CITY PLANNING COMMISSION

APPLICATION: Plan Review of warehouse/office

LOCATION: West of Belleau Wood Lane and 48th Avenue

P86-335

SITE PLAN
 SCALE: 1" = 50'-0"

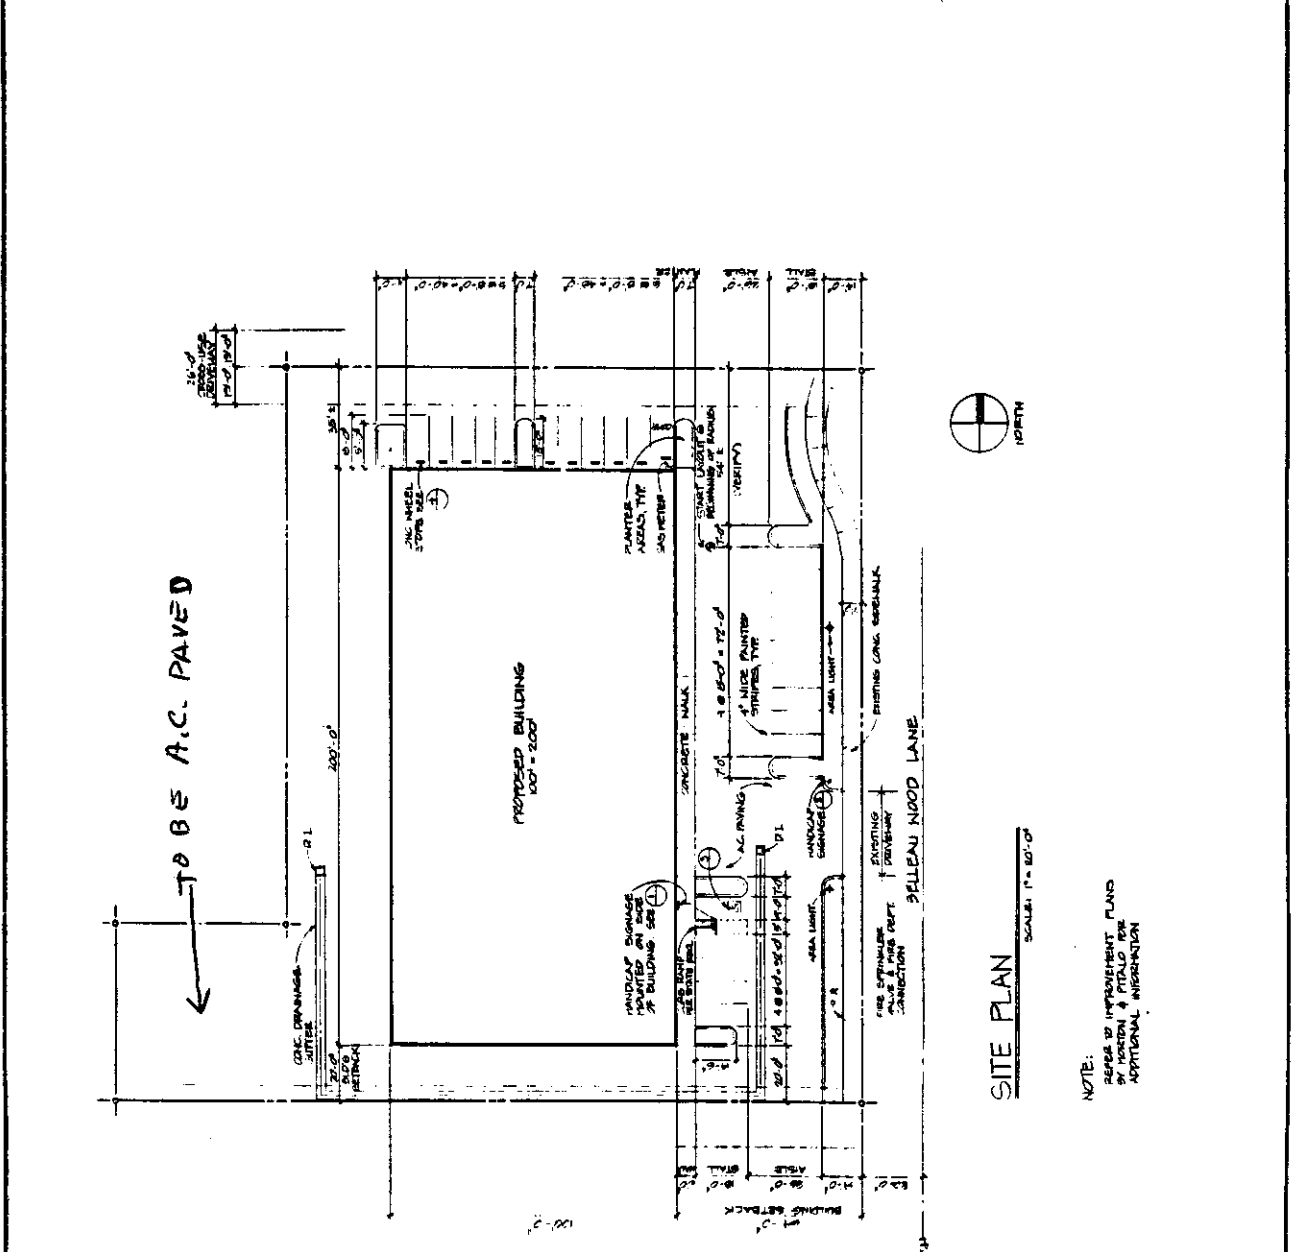
The applicant proposes to develop the site with a 20,000 square foot building, parking lot and landscaping. Ten percent of the proposed building will be office space. Truck loading and unloading doors are proposed along the east side of the building only. The Zoning Ordinance requires one off-street loading space that is a minimum 10 feet wide, 14 feet high and 40 feet long. The applicant has sufficient area adjacent to the east building elevation to comply with this requirement. The southwest corner of the subject site is proposed to be covered with A.C. paving (see site plan). The owners have stated this area will be used to temporarily park vehicles awaiting service or pickup following service.

The 1984 Airport-Meadowview Community Plan designates the railroad right-of-way adjacent to the subject site as a section of future proposed Meadowview Light Rail Transit route. Staff recommends, therefore, that a 10 foot wide planter be installed along the entire west property line of the subject site with five and 15 gallon trees and shrubs to provide some landscape screening of the subject site adjacent to a proposed Light Rail transit route.

Eleven parking spaces are proposed adjacent to the north building elevation. These parking spaces will not have the required backout maneuvering area on the subject site. The applicant intends to use a portion of a proposed driveway located on the adjacent parcel to the north to provide the additional 13 feet of required backout and maneuvering area. The applicant has submitted a letter of intent indicating the terms of the purchase agreement of the subject site (parcel 6) requiring the owner to prepare a cross easement agreement guaranteeing the right to pass over the northerly 15 feet of the subject site for the purpose of maneuvering vehicles (see exhibit A).

The site plan does not indicate a trash bin enclosure. Staff recommends a trash bin enclosure be added to the site plan as per exhibit B.

Staff recommends the applicant submit a signed copy of the proposed cross easement agreement, subject to the review and approval of the Planning Director prior to issuing a building permit.

ELEVATIONS

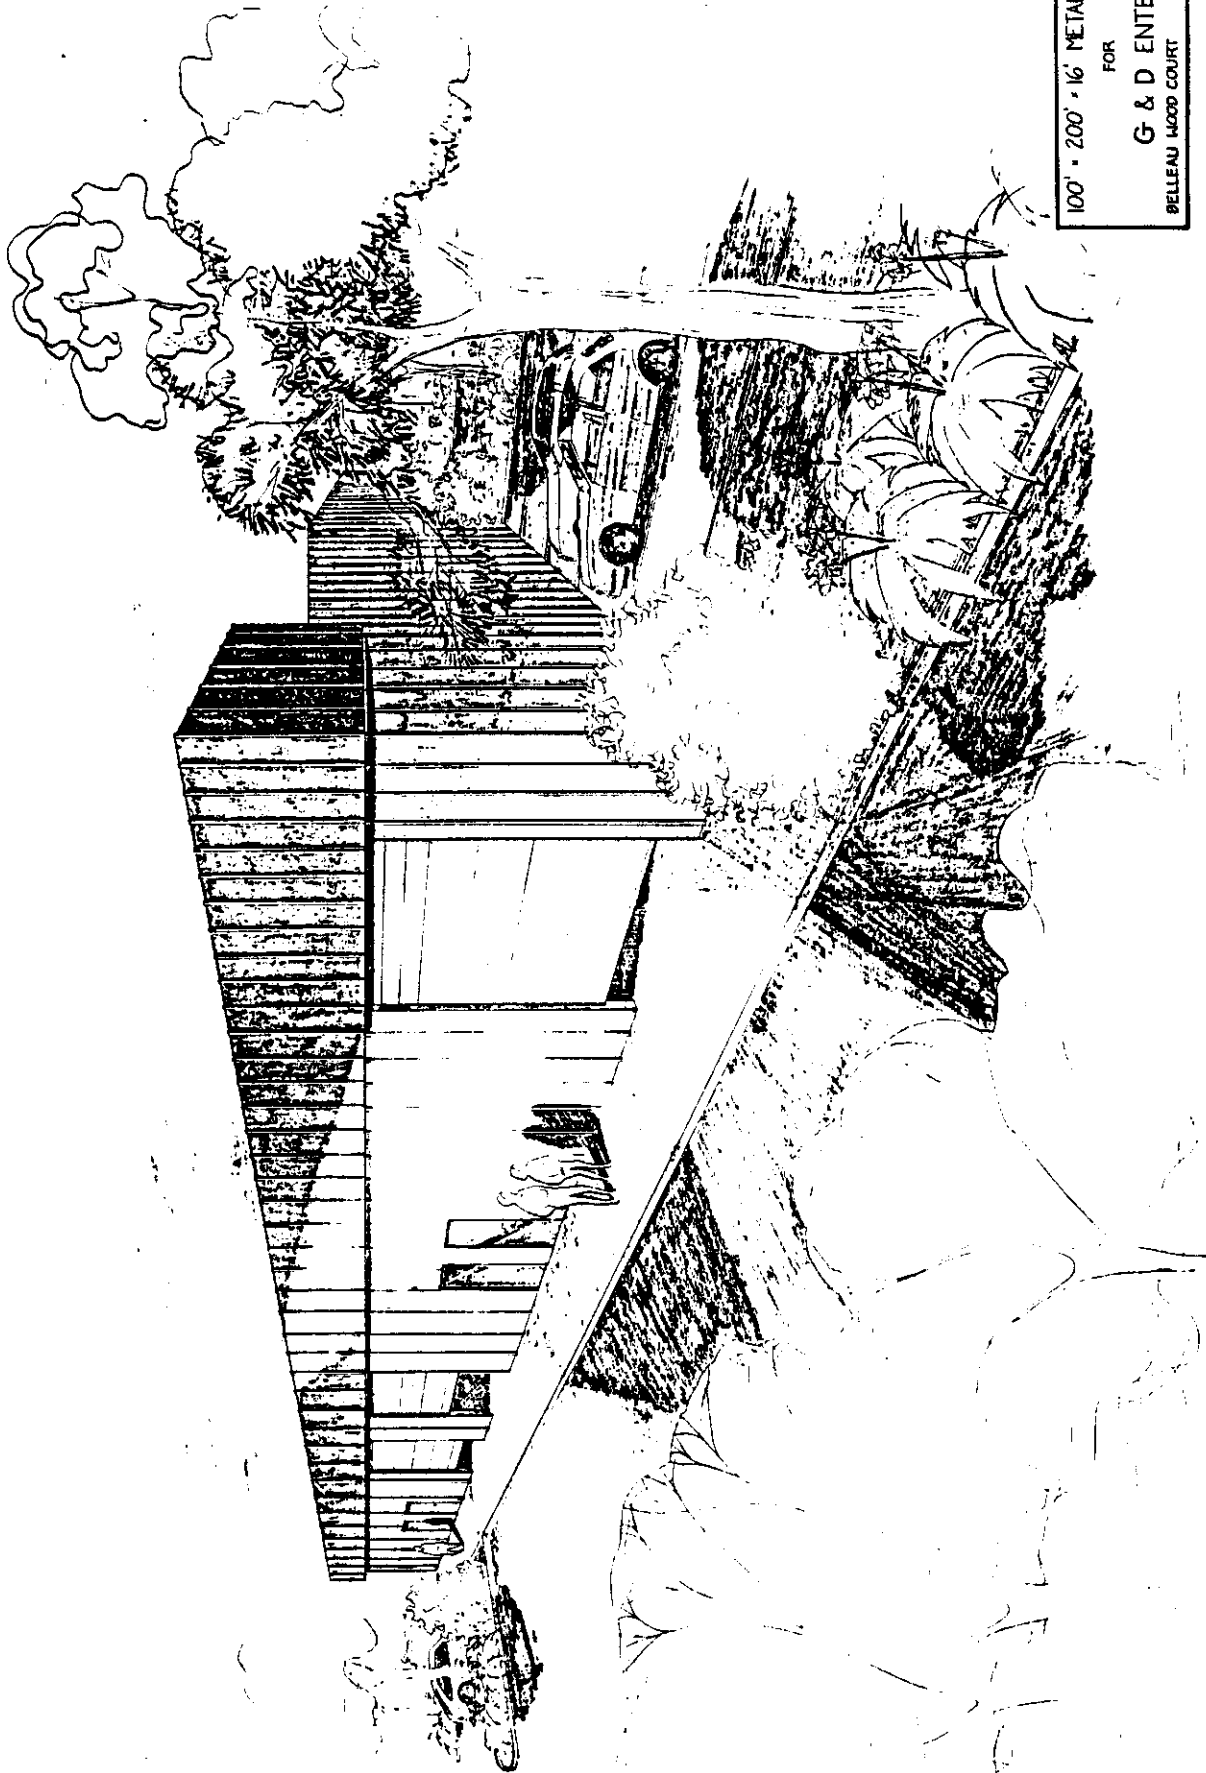
The basic building is a rectangular box with the only openings being provided on the east elevation. There is one metal door opening on the south elevation. The exterior of the building consists of vertical metal panels. A 7'6" high fascia runs

along the east side of the building and returns six feet on the north and south elevation. The fascia extends eight inches in front of the face of the building and the support frame of the fascia can be viewed from below. The total extent of the architectural detailing is the fascia and the vertical trim on each metal panel.

The building is a minimal structure even for an industrial site. Staff can find no redeeming architectural qualities with the proposed structure. The continuation of the fascia around the building would not adequately improve the project. The technology of metal buildings has been developed to the point where more sophisticated architectural design is available.

Staff feels that any design modification by the staff would be merely a band-aid approach. Staff, therefore, recommends continuance of this project so that the applicant can provide the staff with a revised design concept that provides a design enhancement to the neighborhood rather than detracting from the neighborhood.

RECOMMENDATION: Staff recommends the Commission continue this item so that the applicant can submit revised elevations that provide interest and enhance the industrial area.

LANDSCAPE PLANS

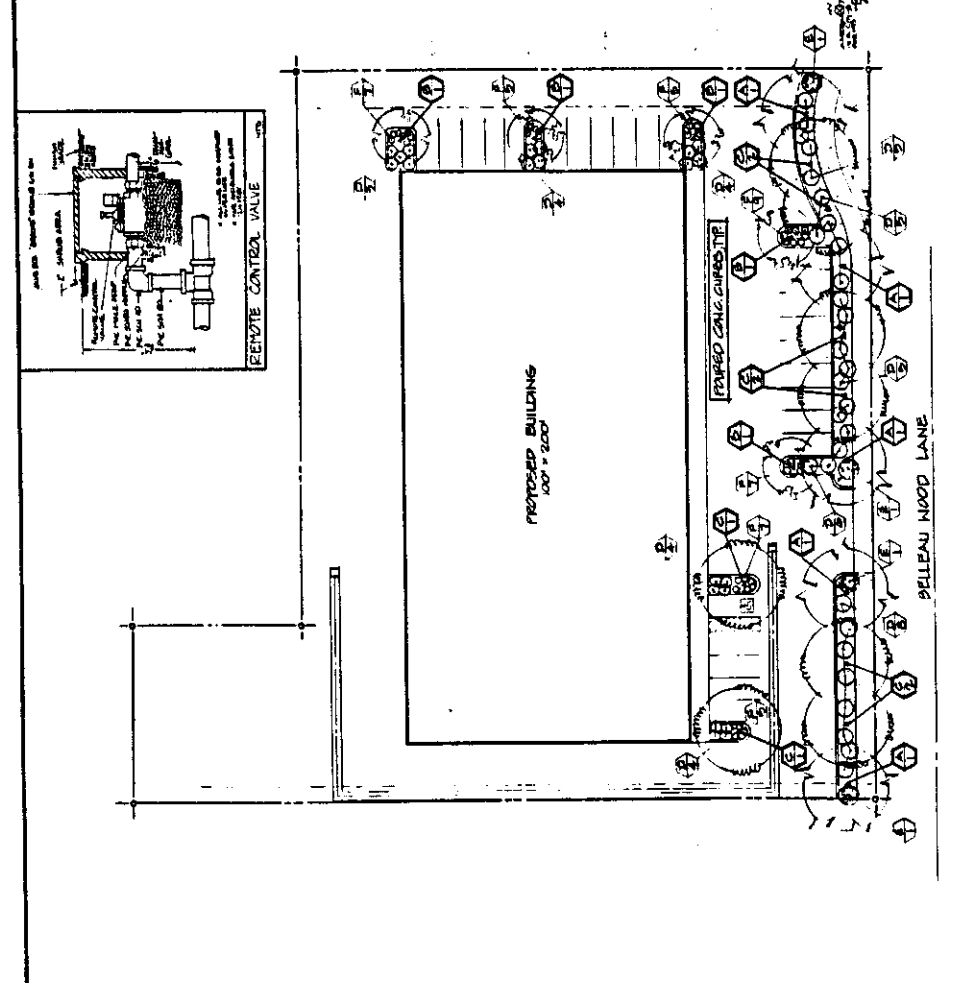
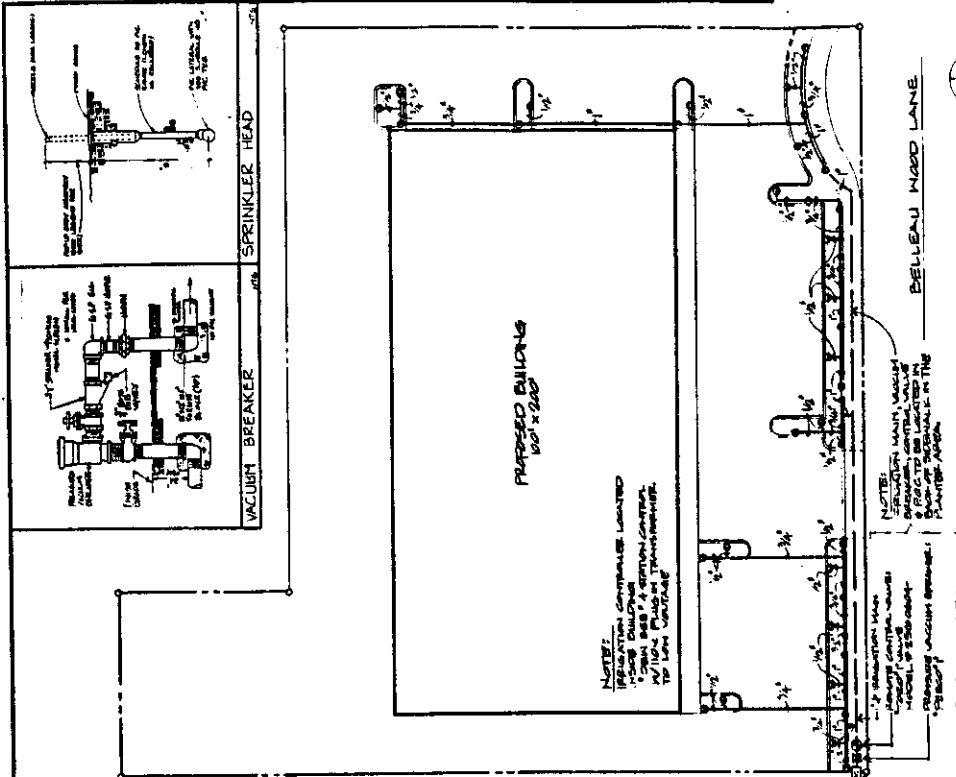
The applicant has submitted landscaping plans indicating a proposed seven foot planter (including curb) adjacent to Belleau Wood Lane and tree shading for the parking lot. The landscaping plans shall be reviewed and approved by the Planning Director prior to issuance of a building permit.
